Office Action Summary	Application No.		Applicant(s)	
	10/591,320		TSUBOI ET AL.	
	Examiner		Art Unit	
	RYAN DODD		3655

This is the fourth office action on the merits for Application Serial Number 10591320, which is a National Stage/371 of PCT/JP04/02737.

This action is in response to the amendment received 30 December 2010. Applicant's remarks have been received, entered, and are being considered by Examiner. Claims 13-18 have been added. **Claims 1-18** are currently pending.

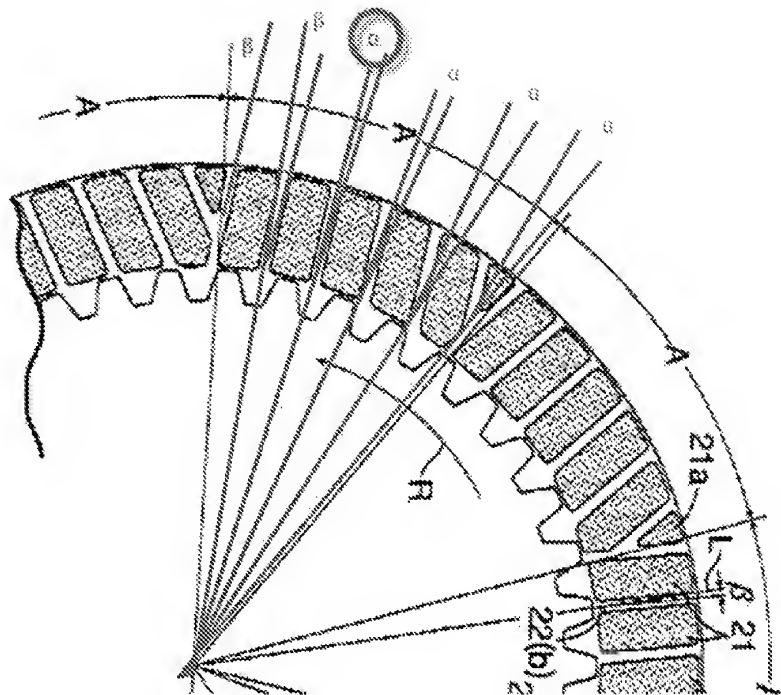
As to **claims 4-6**, the limitation: “wherein the discharge angle (β) is equal to the inflow angle (α)”, may be interpreted to mean that every angle (β), formed by a radial line (L) of the friction plate passing through and inner end of the discharge oil channel itself (claim 1, lines 11-12), of which there are many (see figure below), is equal to every angle (α), of which there are multiple. Although there are particular angles (β) that may be equal to particular angles (α), the interpretation herein presented is not enabled in such a way as to enable one skilled in the art to make the invention, because every angle (β) is not equal to every angle (α).

Similarly, As to **claims 7-9**, the limitation: “wherein the discharge angle (β) is less than the inflow angle (α)”, may be interpreted to mean that every angle (β), formed by a radial line (L) of the friction plate passing through and inner end of the discharge oil channel itself (claim 1, lines 11-12), of which there are many (see figure below), is less than every angle (α), of which there are multiple (see figure below). Although there are particular angles (β) that may be less than particular angles (α), the interpretation herein presented is not enabled in such a way as to enable one skilled in the art to make the invention, because every angle (β) is not less than every angle (α).

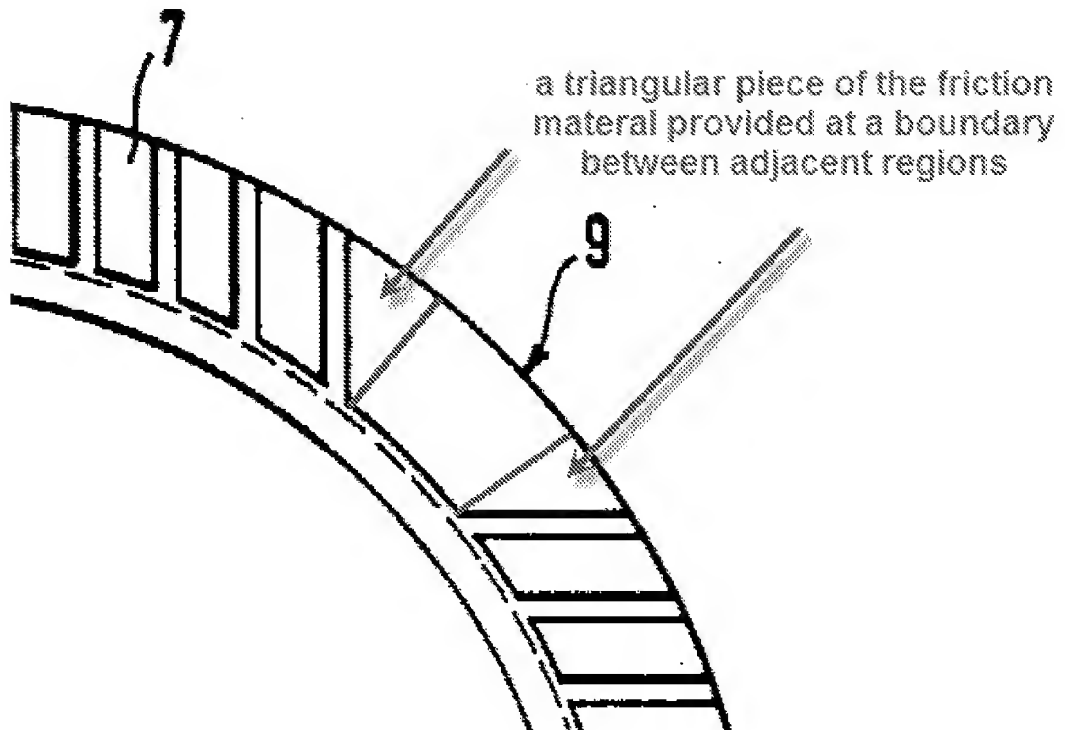
As to **claim 2**, Bauer '282 discloses that the friction plate is divided into a plurality of regions (A) arranged in the peripheral direction, each region including an equal number of discharge and inflow oil channels (for instance in Fig.3 Bauer '282 implies 4 regions).

As to claim 3, Bauer '282 discloses a triangular piece of the friction material that is provided at a boundary defined between adjacent regions (see figure below).

As to **claims 4-9**, as best understood, at least one discharge angle (β) of Bauer '282 is equal to at least one inflow angle (α), and at least one discharge angle is less than at least one inflow angle, as measured from a radial line L (See Fig.2, and figure above).
